City of Phoenix
PLANNING & DEVELOPMENT DEPARTMENT

Subject: P.H.O. APPLICATION NO. PHO-1-26--Z-29-23-7(8) – Notice of Pending Actions by the Planning Hearing Officer

APPLICATION NO: PHO-1-26--Z-29-23-7(8)

Request For: Stipulation Modification

lot 4 conceptual elevations

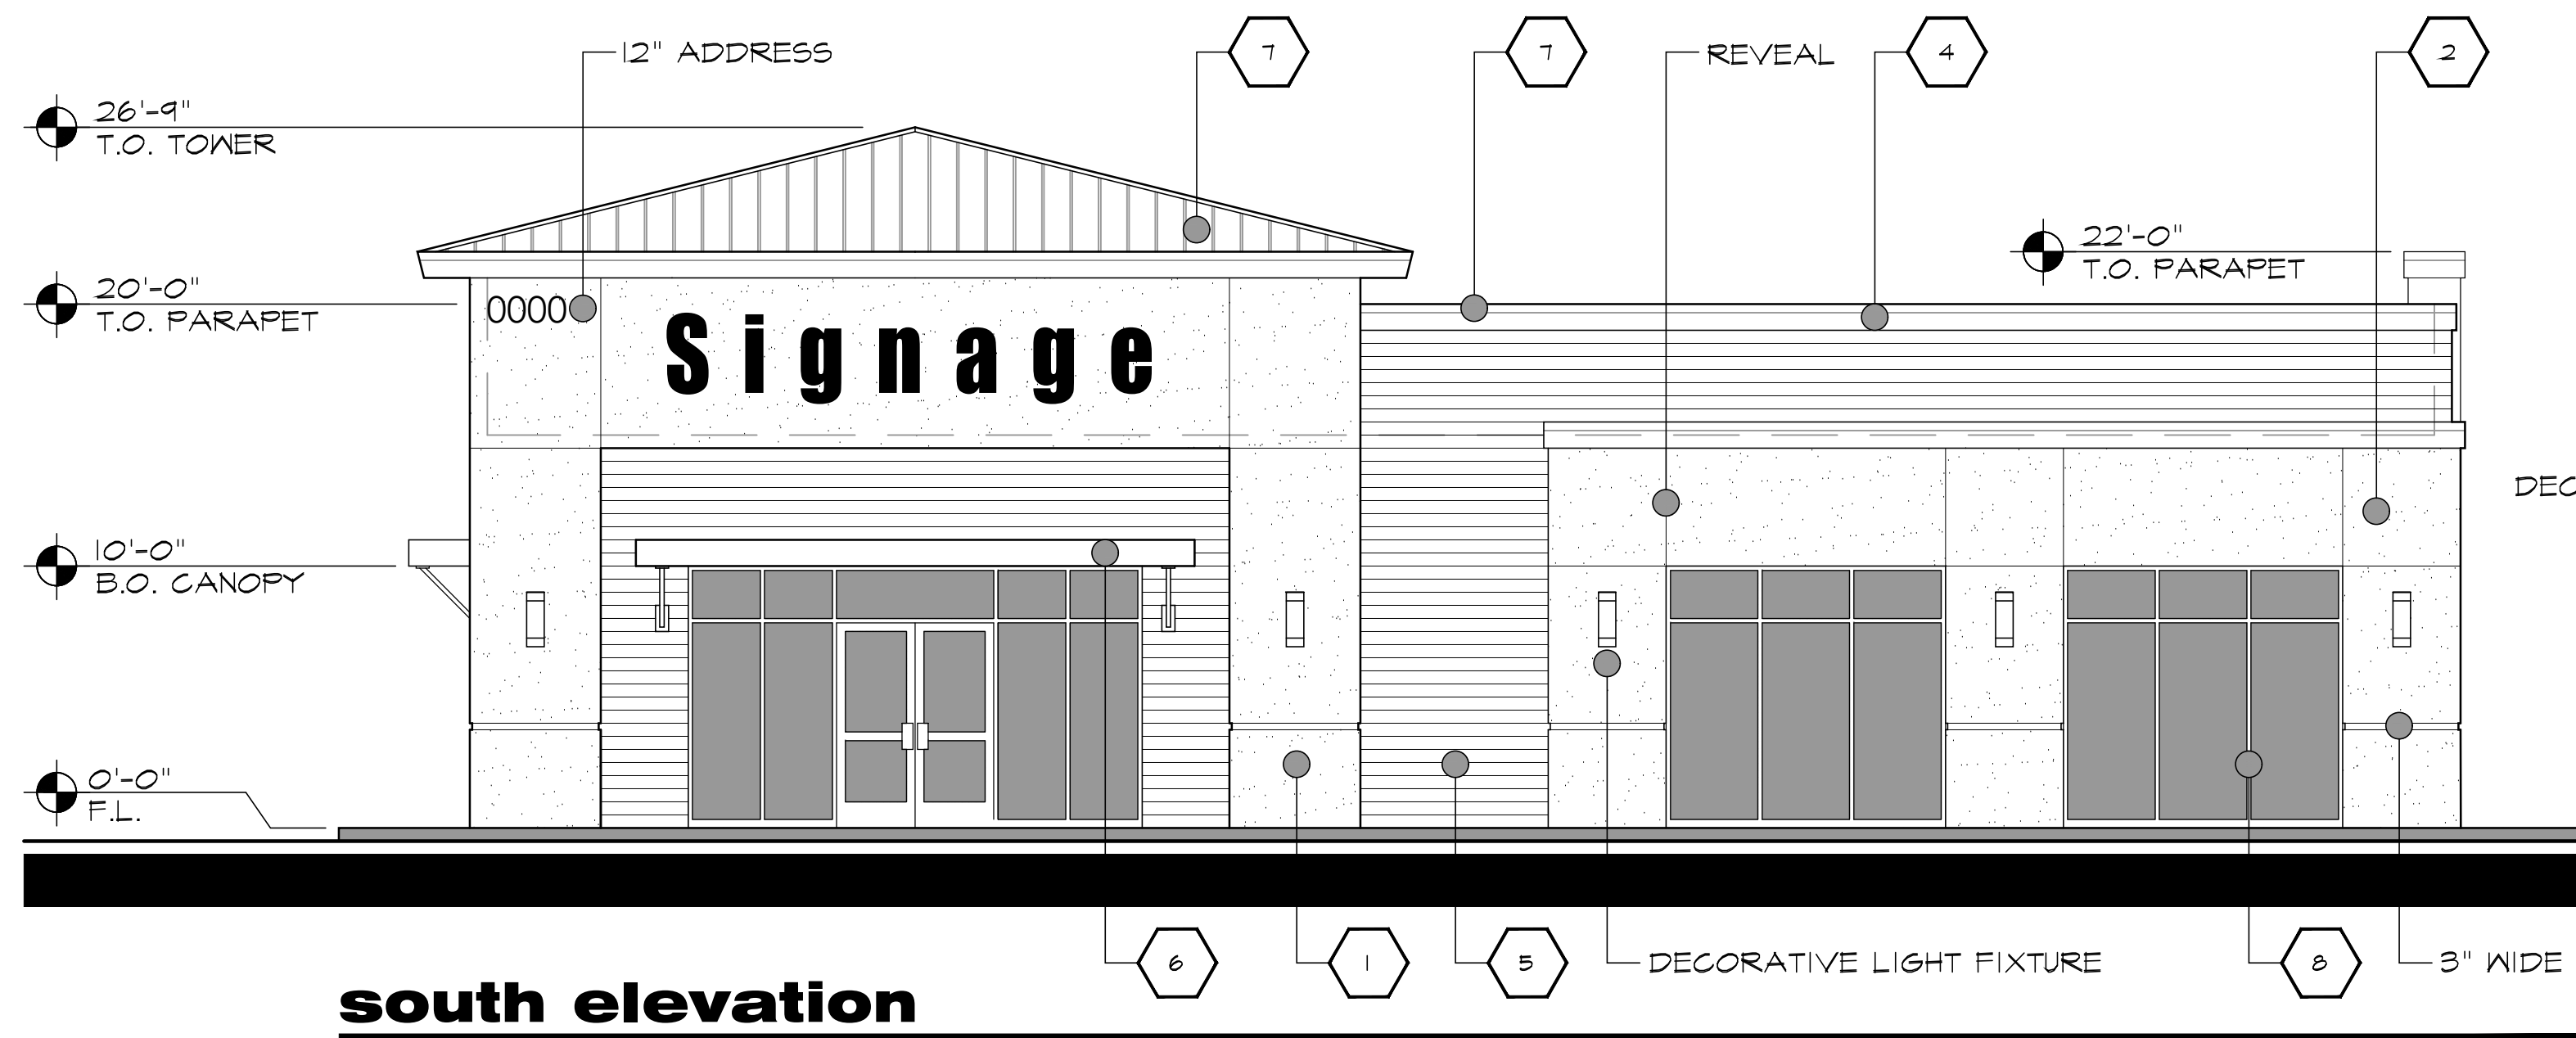
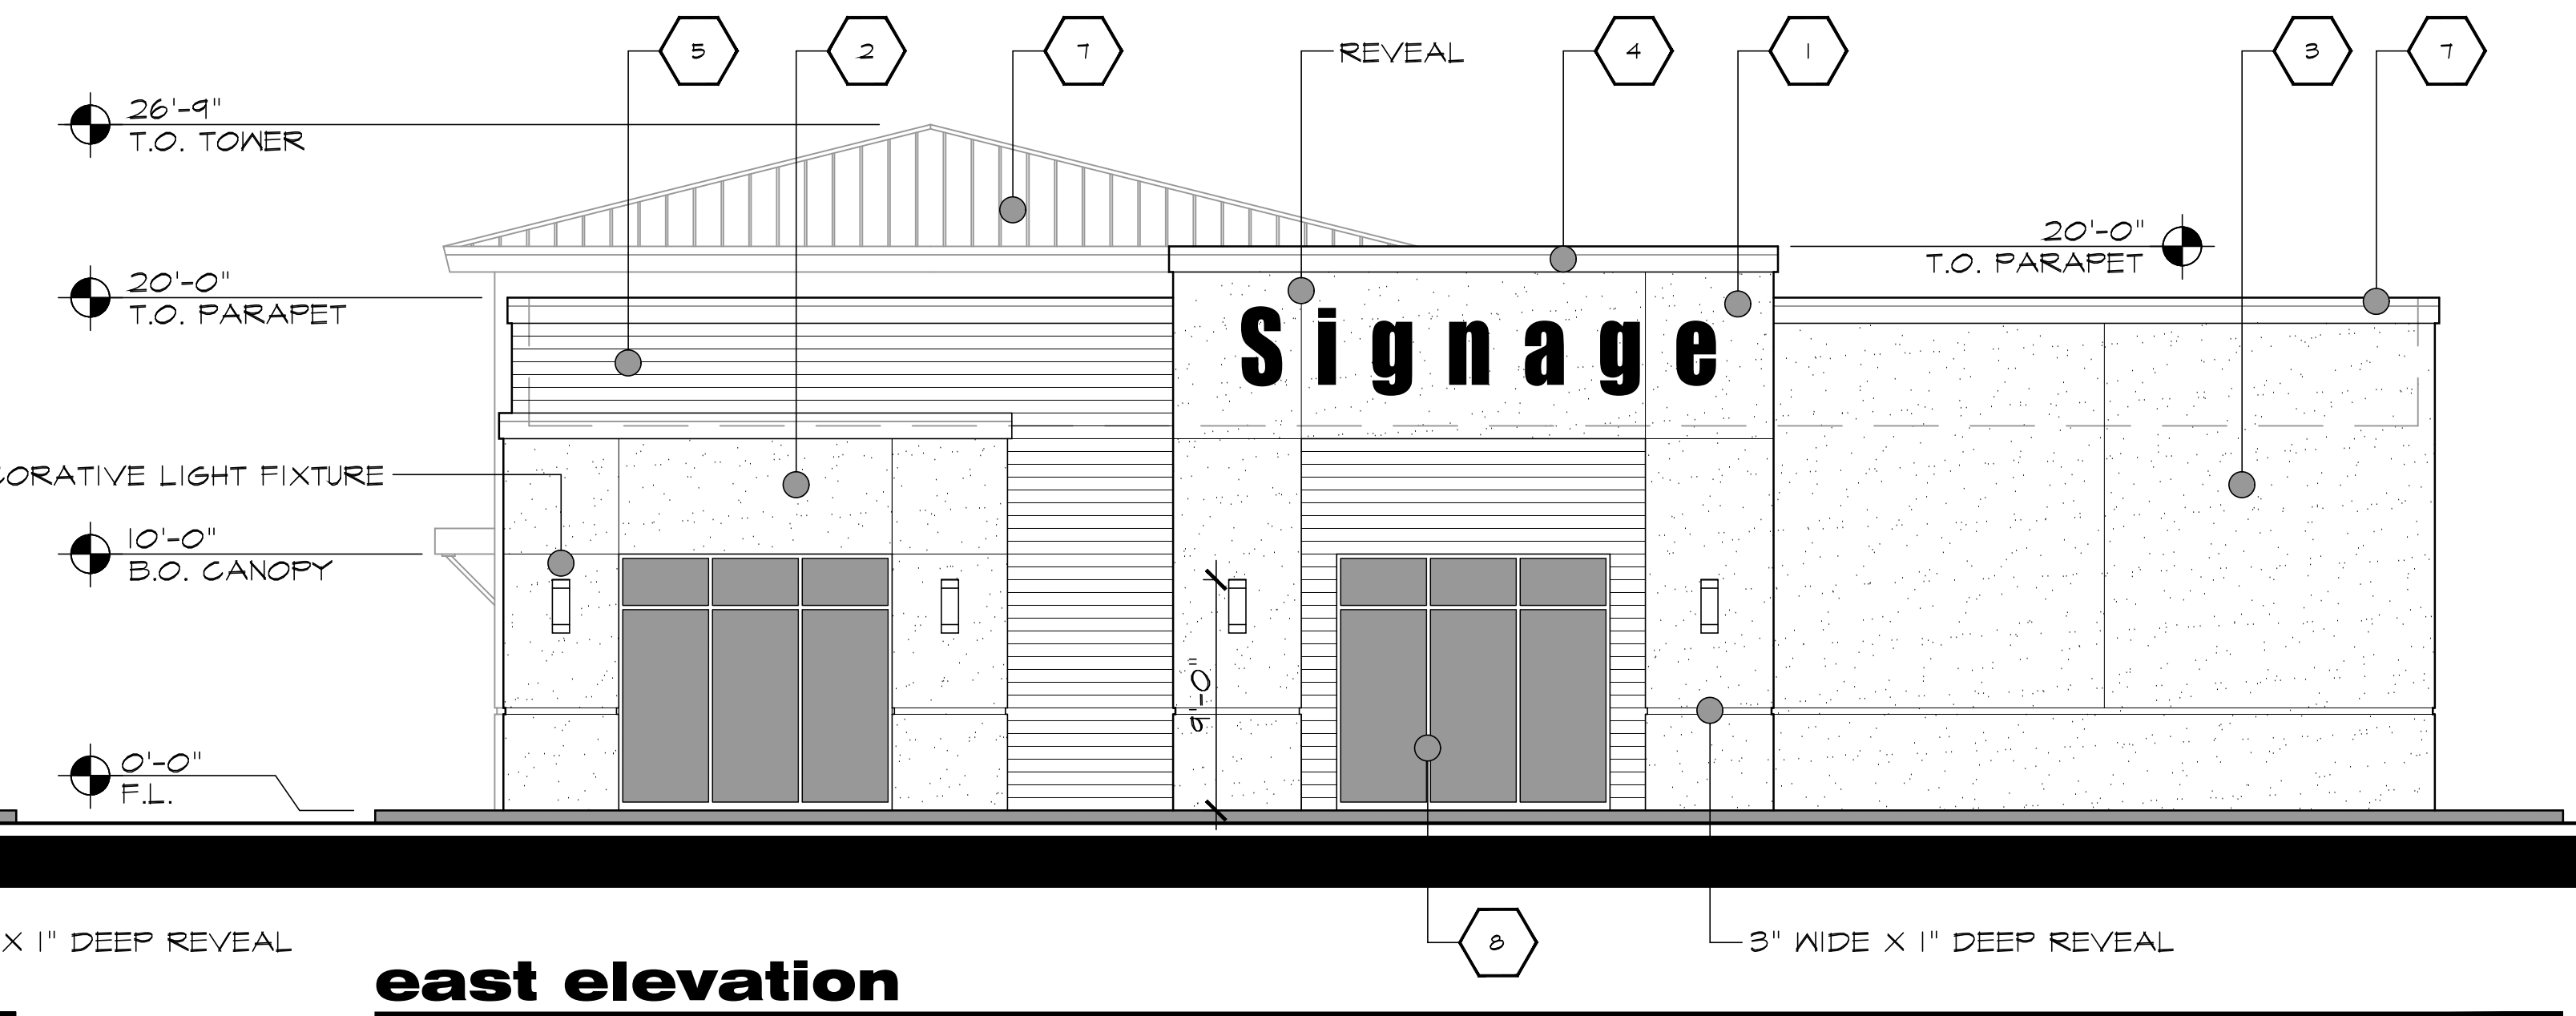
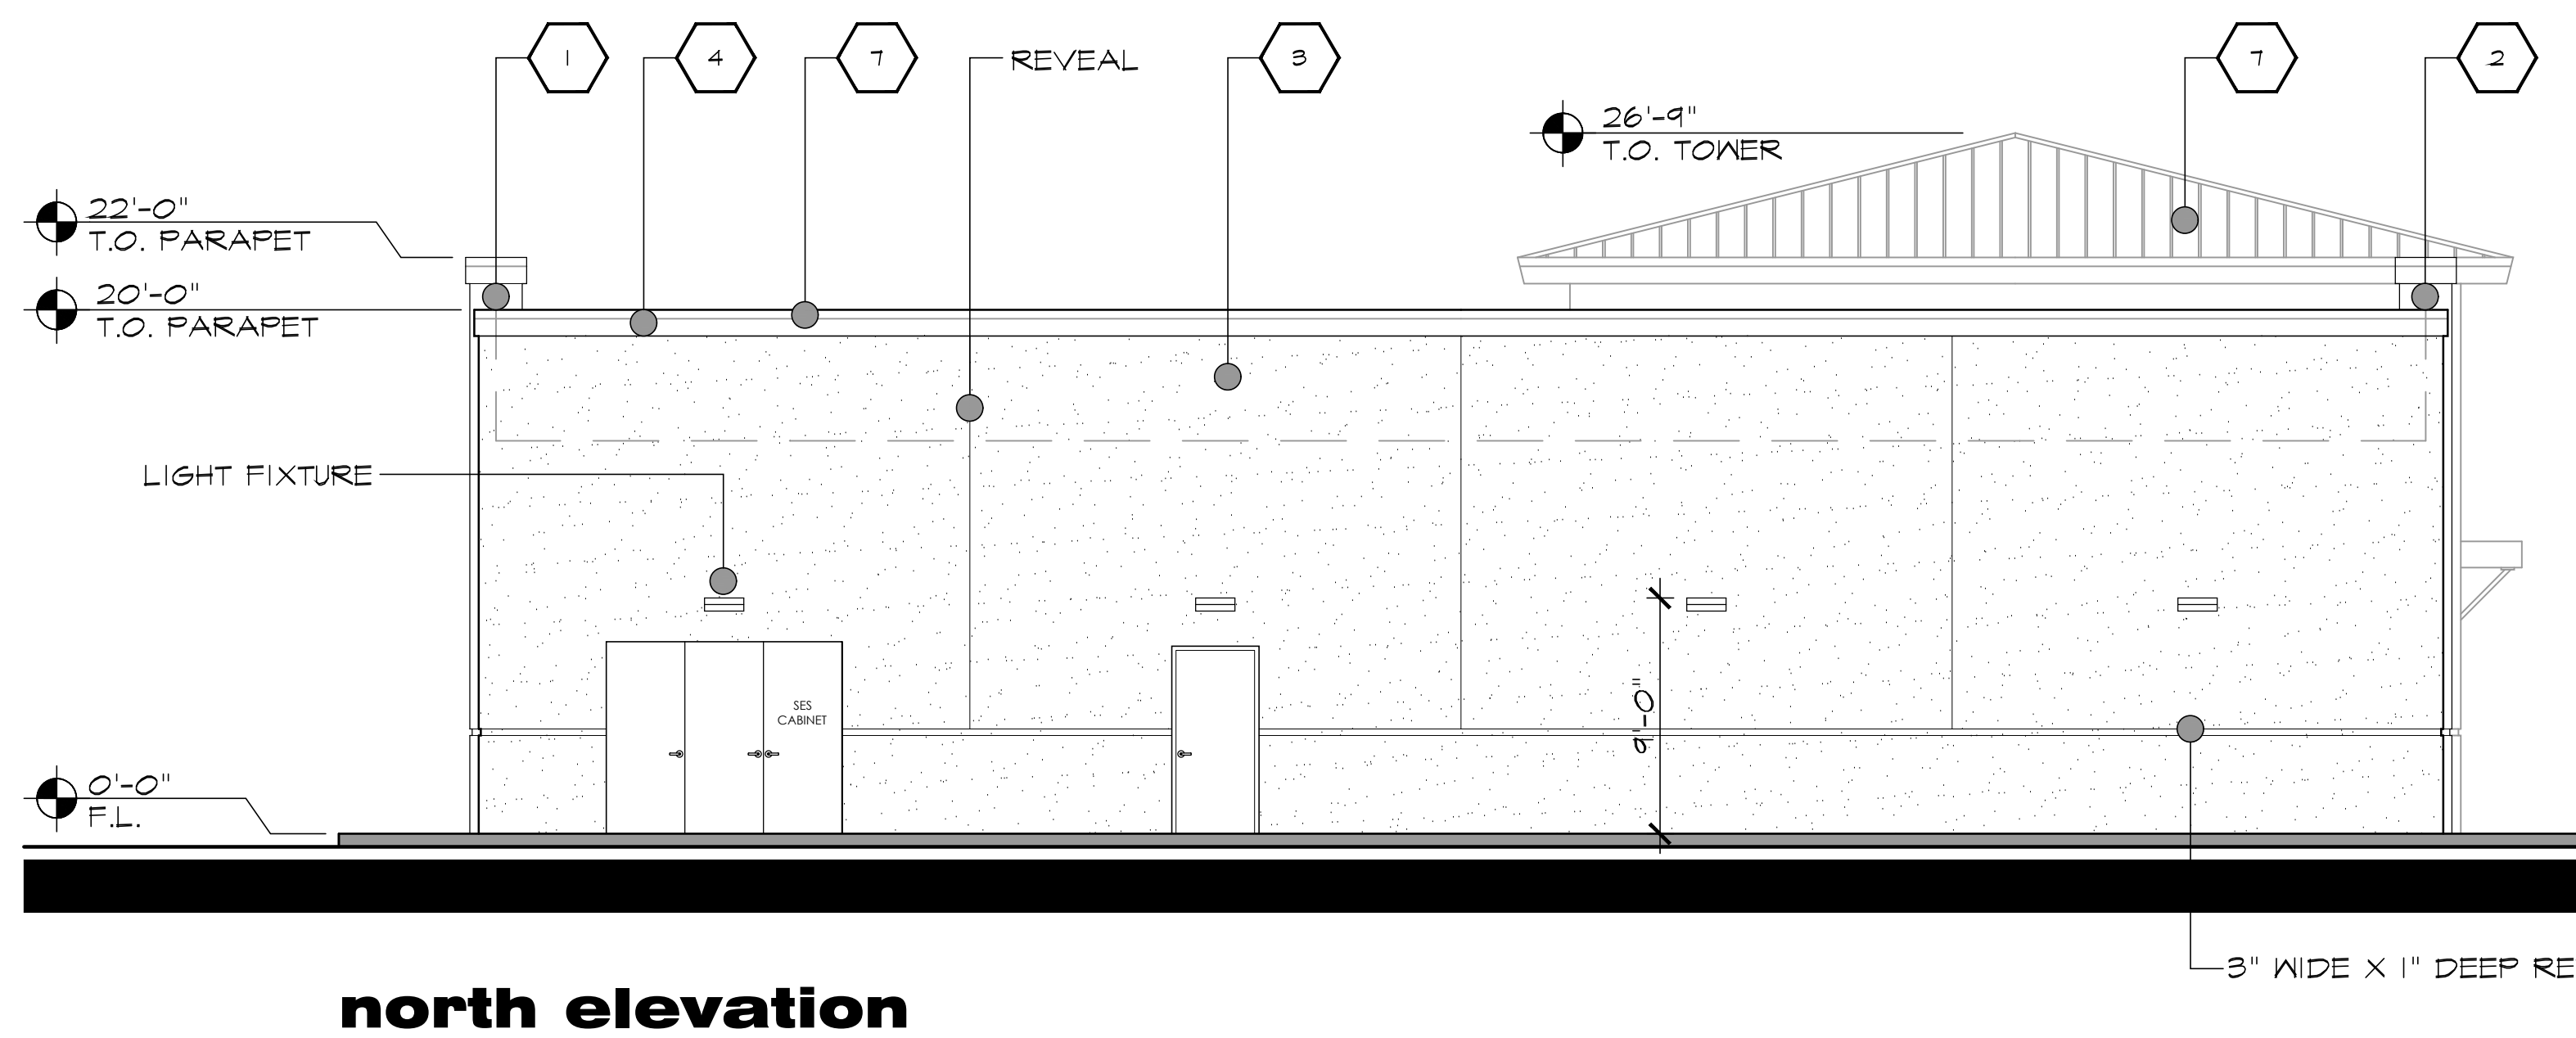
We respectfully request your review of the site plan and elevations for Lot 4 and the forementioned modifications and deletions of stipulations in Z-29-23-7. Thank you for your time and attention to this matter.
